AUBURN HILLS 12TH ADDITION

RE: S/D 00-09 -- Final Plat of AUBURN HILLS 12TH ADDITION

At the regular meeting of the Subdivision Committee of the Metropolitan Area Planning Commission on Thursday, March 9, 2000, the above captioned plat was considered. The action of the Committee was to approve the final plat, subject to:

CASE NUMBER: S/D 00-09 -- AUBURN HILLS 12TH ADDITION

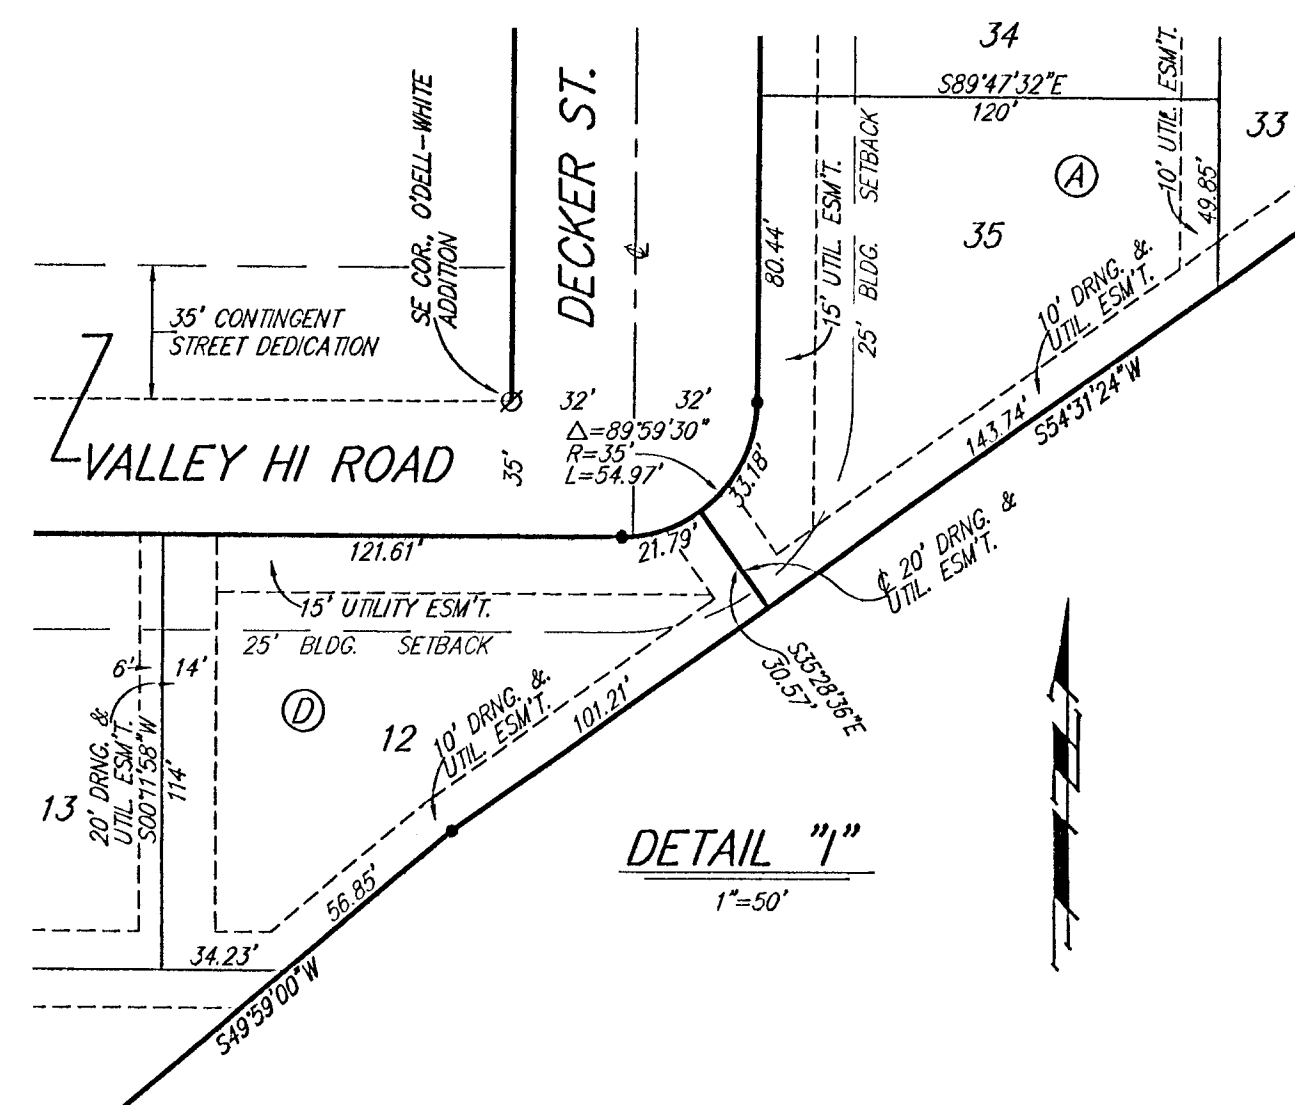
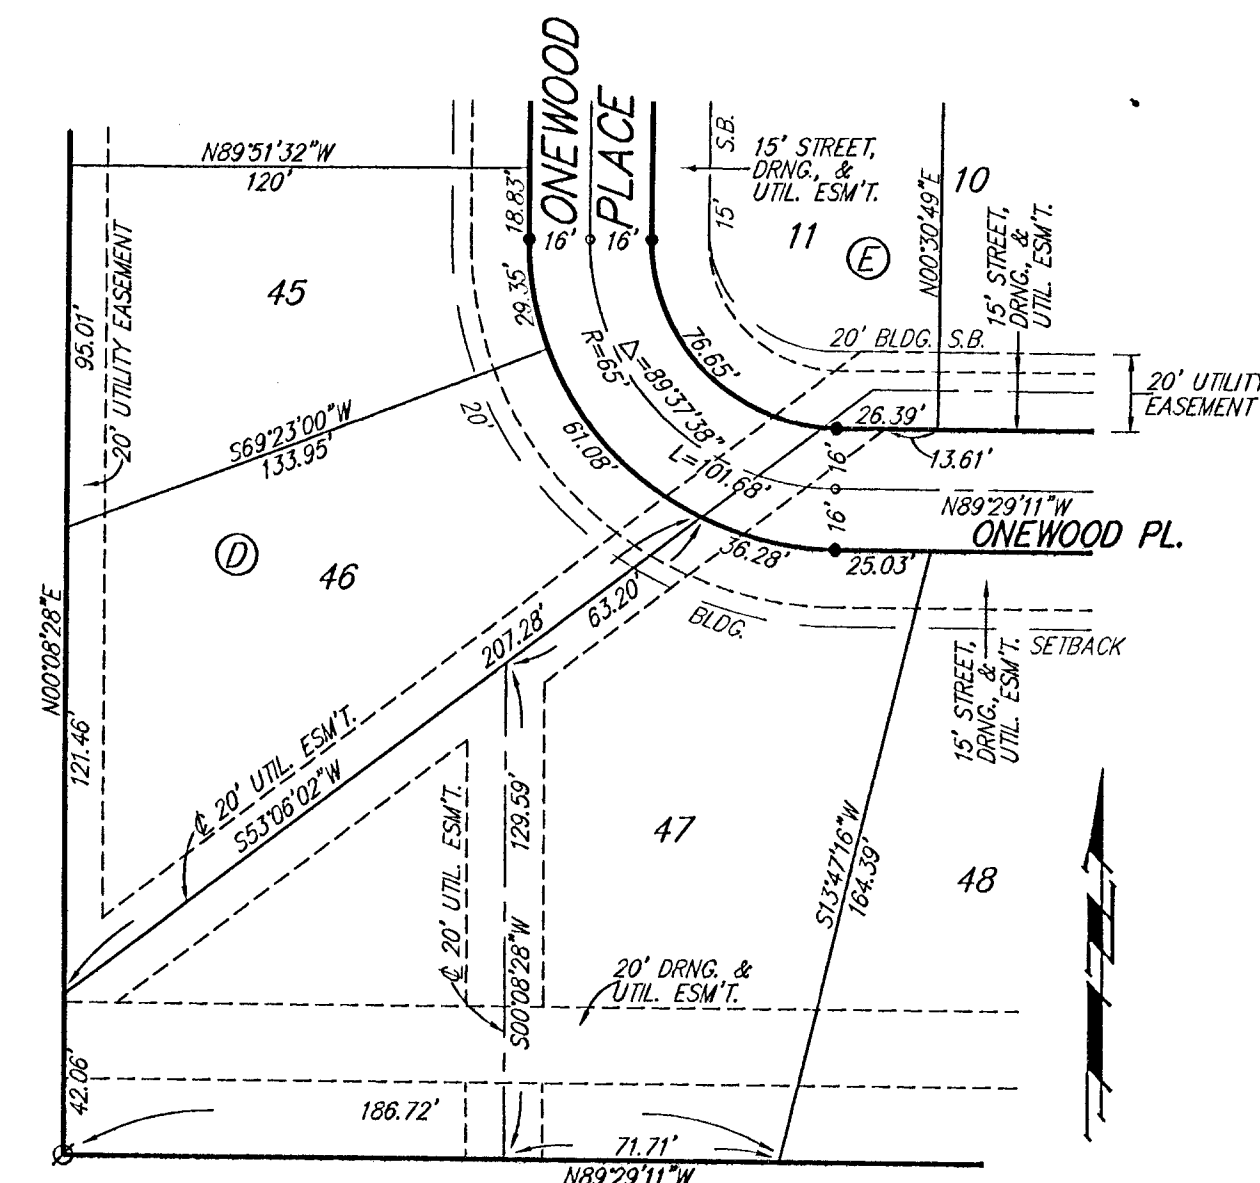
- C. City Engineering needs to comment on the status of the applicant's drainage plan. The drainage plan is approved. A drainage guarantee is required. Drainage easements need to be included on the final plat tracing.

- D. A temporary turnaround will need to be provided at the western terminus of Onewood.
- E. The applicant shall guarantee the paving of the interior streets, Valley Hi Road and the portion of Decker and Taft which adjoins the lots in this plat.

- H. City Fire Department should comment on the acceptability of the plat's street names. Decker Drive should be Decker Street. Nineiron Place should be Nineiron Court.

- I. The Applicant shall dedicate an additional 6 feet of right of way along Valley Hi Road in order to activate the contingent right-of-way dedication along the northern half of the street.

- J. To provide an additional point of access for the lots located on Onewood Place, City Fire Department requests an emergency access easement to connect Onewood Place with Valley Hi Road or Decker.

- P. The definite location of the gas easement needs to be denoted for Lot 47, Block D.
- Q. Dimensions need to be added for the following: Between lots 8 and 9, Block A; the north line of Lots 12 and 13, Block A; west line of Lot 14, Block A; and the south line of Lot 7, Block C. -

- Z. The representatives from the utility companies should be prepared to comment on the need for any additional utility easements to be platted on this property. *KGE has requested additional easements.*
